## 1. Boreham Main Road B1137 - mitigation measures

#### 2. Historic severance between Boreham and Hatfield Peverel

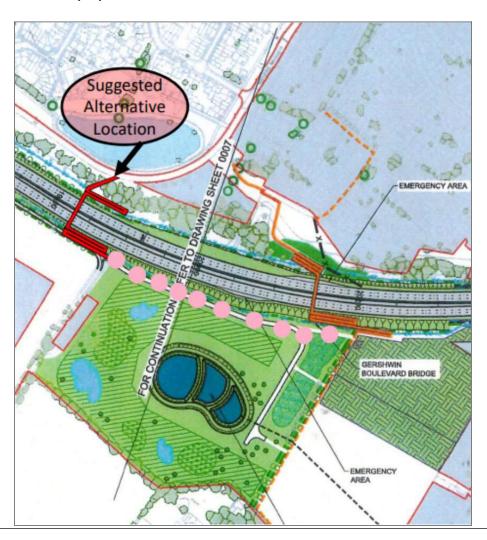
Many parties have said that they wish to see Gershwin Boulevard WCH bridge moved slightly west — see also ELAF's comments at deadline 5 and 6 [REP5-035 and REP6-111]. ECC in their REP4-075 included a plan — see below - showing the bridge moved slightly west but STILL entirely on land within the draft DCO Order limits with the direct connection to Howbridge Hall Lane, a public road, and a link on National Highways land to Witham FP 95 [PROW 121\_95]. This would facilitate a link south to James Cooke Wood and east to Witham FP95 and, via the replacement open spaces land, to Maldon Road.

#### **ELAF** request that the ECC proposal is included in the draft DCO.
